HISTORIC AND DESIGN REVIEW COMMISSION

HDRC CASE NO: 2016-025
ADDRESS: 224 E CAROLINA ST
LEGAL DESCRIPTION: NCB 2956 BLK 0 LOT A
ZONING: RM4 H
CITY COUNCIL DIST.: 1
DISTRICT: Lavaca Historic District
APPLICANT: Ramon Torres/Turn Key Pros
OWNER: Rodney Anderson
TYPE OF WORK: Construction of a rear porch
REQUEST:

The applicant is requesting a Certificate of Appropriateness for approval to reconstruct the front porch at 224 E Carolina and restore all existing wood windows. At this time, the entire porch foundation, one column and small portion of the roof structure exist.

FRONT ELEVATION

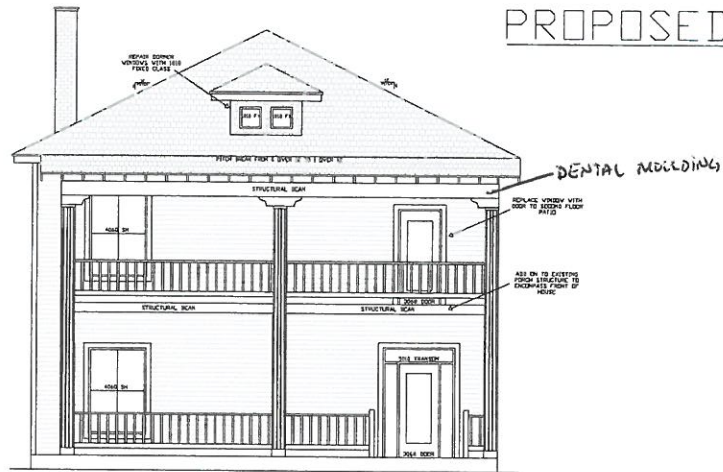
- a. The structure at 224 E Carolina was constructed circa 1900 and is a foursquare with Italianate architectural features. On the street facing façade, the applicant has proposed to reconstruct a partially demolished double height front porch of which one double height column, the existing foundation and partial roof structure remain.

- b. According to the Guidelines for Exterior Maintenance and Alterations 2.B.v., porches and balconies should be reconstructed based on architectural evidence of the original, such as photographs or remaining architectural details. The applicant has proposed to construct three columns to match the existing one to be evenly spaced on the front façade, restore the dental molding and middle fascia. This is consistent with the Guidelines.

- c. On the lower and upper levels of the proposed reconstructed porch, the applicant has proposed to install porch railing. While there is no evidence that this specific structure featured railing on the bottom level, staff finds this proposal architecturally and historically appropriate.

Staff recommends approval as submitted based on findings a through d.
